“Channel” vs “Link section” effects on pair-to-pair resistance unbalance requirements

September 2017

Yair Darshan

Rev001a

Background – D2.4 vs D3.0, Long Cable model.

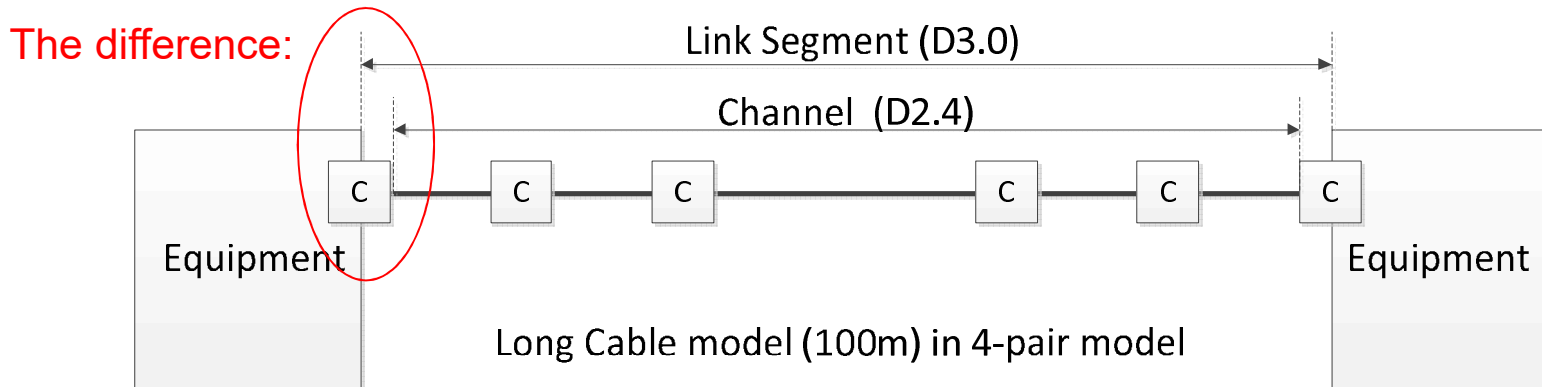
- PSE PI – equipment connector (the plug + jack) was part of the PSE PI.
- PD PI – equipment connector (the plug + jack) was part of the PD PI.
- “Channel” – consist of up to 4 connectors and 100m cordage and cable.
- Resulting with total 6 connector model from end to end.

- Link section – Includes the “Channel” connectors + the plugs going to the equipment with 100m cordage and cable. The Equipment include the Jack only.
- The question is: does it changes pair-to-pair unbalance requirements?

Background – D2.4 vs D3.0, Short Cable model.

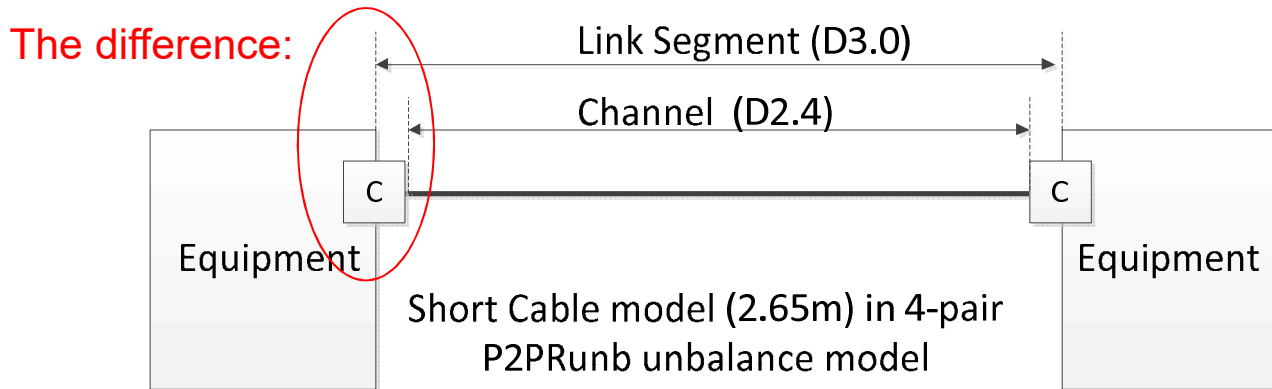
- **In D2.4**
 - PSE PI – equipment connector (the plug + jack) was part of the PSE PI.
 - PD PI – equipment connector (the plug + jack) was part of the PD PI.
 - “Channel” – consist of 0 connectors and 2.65m cordage.
 - Resulting with total 2 connector model from end to end.
- **In D3.0**
 - Link section – Include the plugs of the short “Channel” cable.
 - The PSE PI and PD PI include only the jacks.
- **The question is: does it changes pair-to-pair unbalance requirements?**
